## Comparison of an Ultrasonic Phased Array Evaluation with Destructive Analysis of a Documented Leak Path in a Nozzle Removed from Service

AD Cinson, SL Crawford, PJ MacFarlan, BD Hanson, and RA Mathews  
Pacific Northwest National Laboratory<sup>1</sup>, Richland, WA, USA

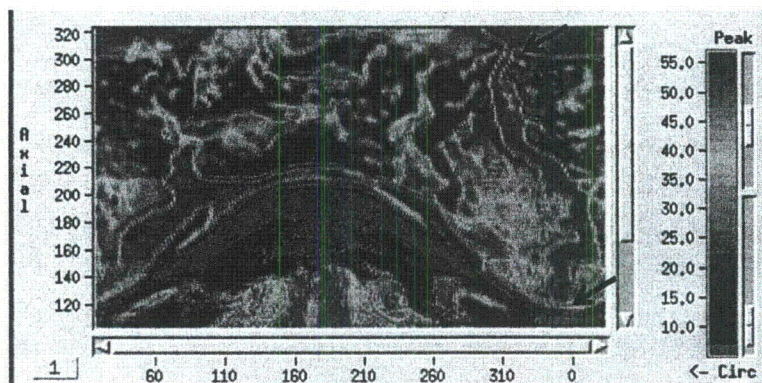
**Comment [PG011]:** Confirm you have permission to use this figure and make publically available.

Figure 6 – A composite 360-degree ultrasonic data image from Nozzle 63. The vertical axis represents 360 mm (14.17 in.)

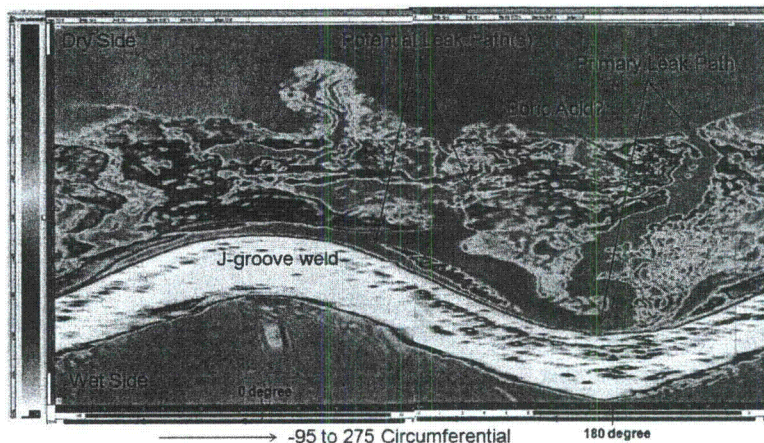
Comment [PG012]: at the

Comment [PG013]: in

Figure 8 – Replicated leak path on the left and piece 4 on the right with machining marks evident. The red line on the right represents 2.0 mm (0.80 in.) in length.

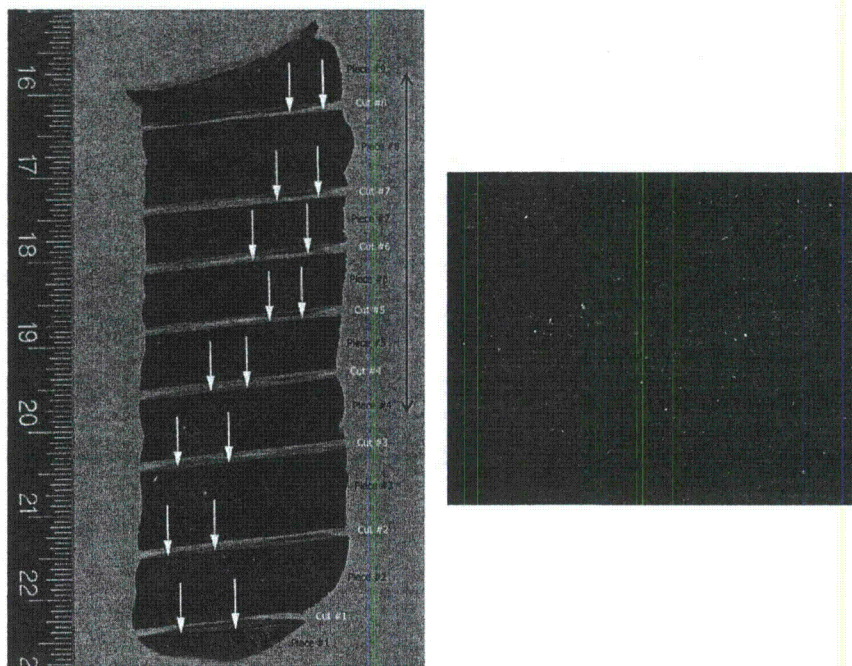
**Comment [PG015]:** Make it clear that this statement applies to the presence of visible machining marks, not the corroded area.
